**AMENDED AGENDA**  
Regular Virtual Meeting  
Canton Planning and Zoning Commission  
Wednesday, November 18, 2020 at 7:00 pm  
**Call-In Number:** +1 (571) 317-3122  
**Access Code:** 152-792-853

### **Exhibit List for:**

**File 475; Apln 2000;** 9 and 15 Albany Turnpike; Assessor Map 32 and 36; Parcel 1010009 and 1010015; Zone: B; Special Permits: Section 4.1.C.1.a., retail/service businesses and personal service businesses greater than 2,500 square feet; Section 4.1.C.2.b., outdoor dining when accessory to restaurant classes I, II, or III; Section 4.1.C.3.a., drive-thru uses; Section 4.1.C.10.a., new car dealership, as defined by CGS Section 14-51(1); Section 4.1.C.10.e., gasoline filling stations; Section 7.3.F.8.a., sign approval by special permit; Section 7.5.D.3., earthwork and grading over 2,000 cubic yards; Section 7.7.C.3., retaining wall by special permit; Section 7.10.B.2, outdoor storage and display; and Site Plan Application: Section 4.1.B.3., restaurant classes I & II; Section 9.1.A., request to construct a 8,384 sq. ft. gas station/convenience store with restaurants and drive-thru, and 23,500 sq. ft. electronic vehicle showroom with 117 associated parking spaces;

Figure 1 - Retaining wall next to Kohl's at The Shop's

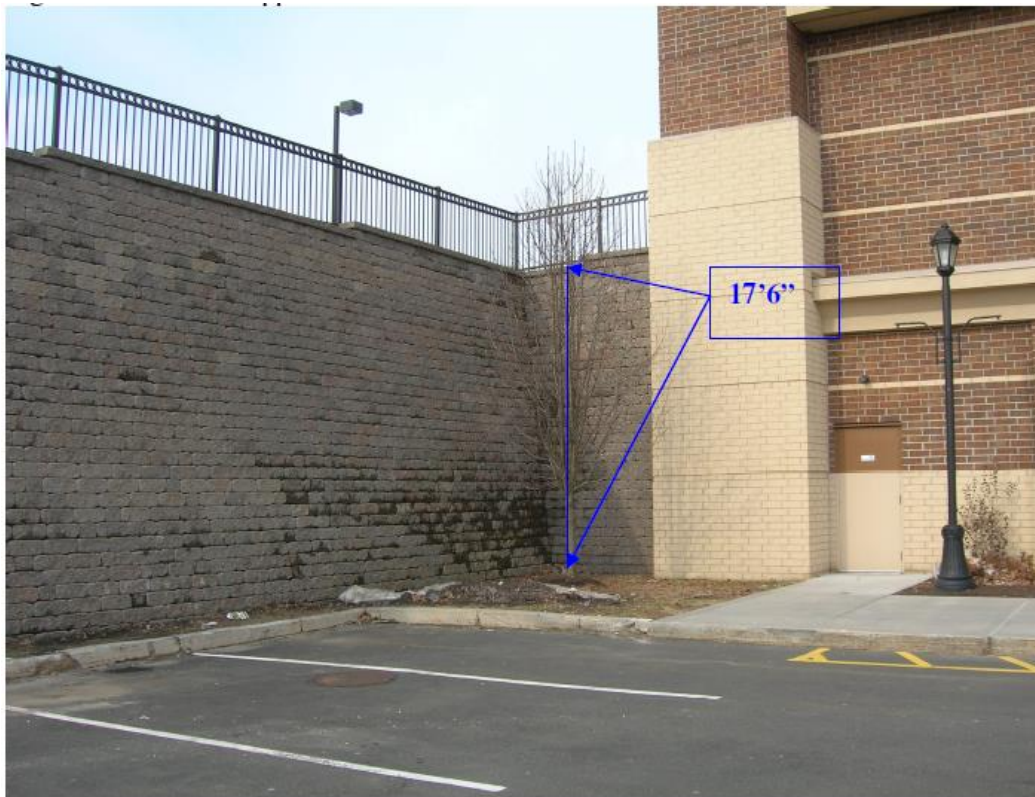
Per 7.7.c this may be a “series” of walls, or “stepped” walls which would require separation and grading between. See 7.7.c.2.b. Applicant to clarify.

- d. A fence will be provided at the top of the retaining wall, the height of which is not identified. – **Not identified.**
- e. The Special Permit Criteria of 9.2.E must be evaluated in relation to the proposed walls – **The Commission must be able to clearly understand what is occurring regarding the proposed walls.**
- f. Proposed walls.

*Figure 2 - Retaining Wall along Route 44, Behind Shoprite*

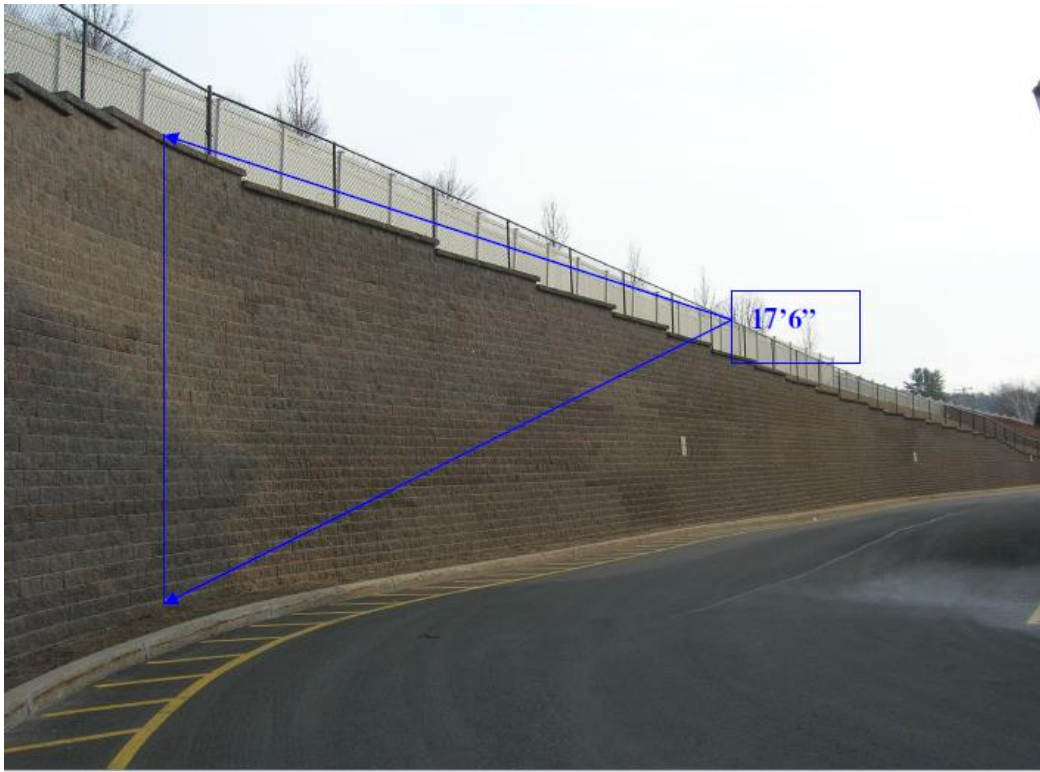
51' Tall Retaining Wall on Grading Plan (No retaining wall shown, or minimally shown)  
38' Tall Building

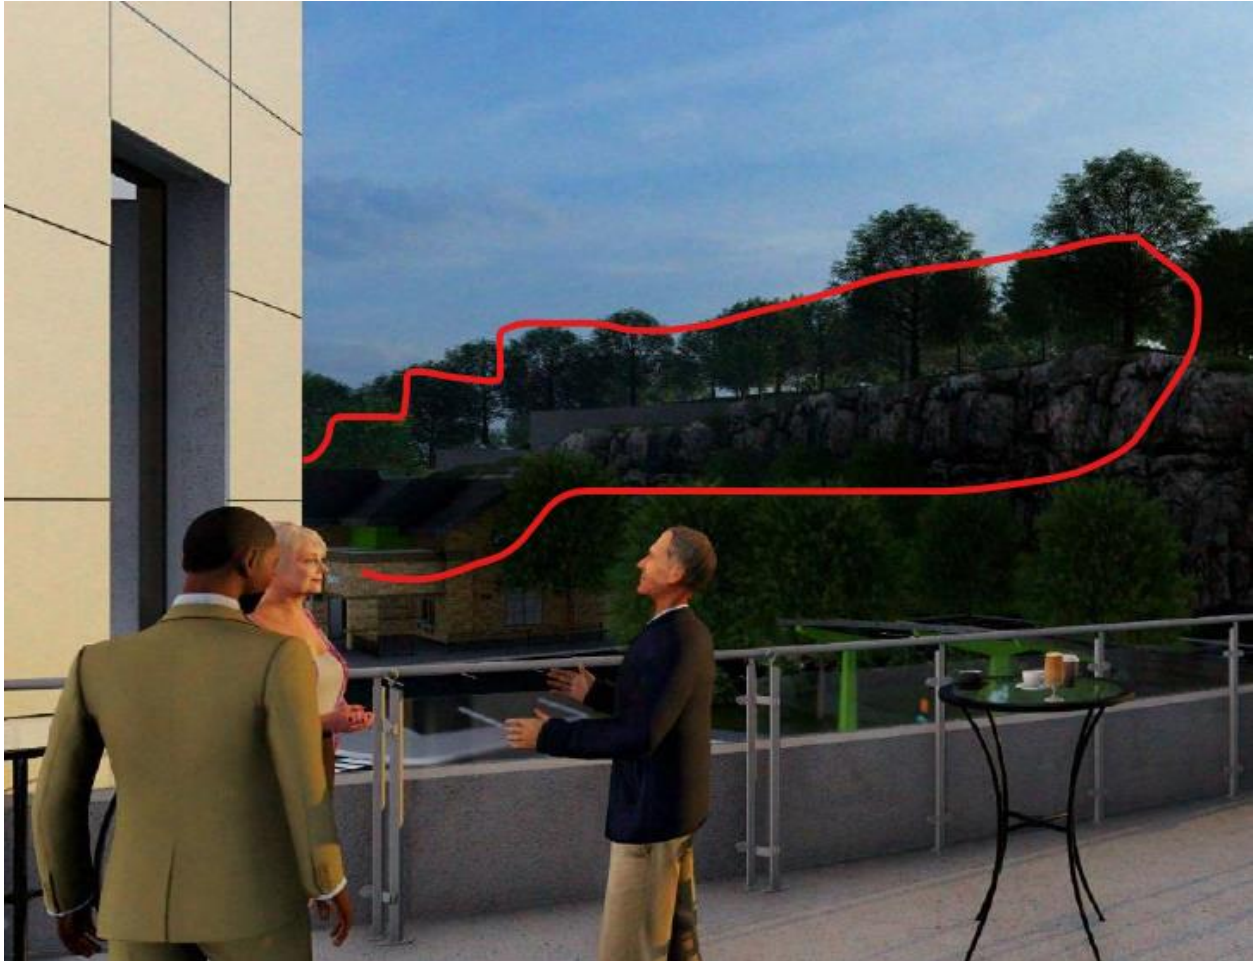
**Imagery shows retaining walls on top of rock walls. Retaining wall appears to be stepped on top of rock wall. See also stepping presented in Figure 8.**

**It is not clear what the retaining walls will actually look like, what the vertical and horizontal limits will be, and their anticipated magnitude or presence within the site. The Commission should not grant a special permit for walls without a clear understanding of what is proposed.**

*Figure 8 – Stepped Wall in background. (Note – confirm location of access drive to the rear of the property. It would seem to run through this area generally where trees are prominently shown and may be removed, or view will be different, if not proposed or required as part of an approved landscaping plan.)*
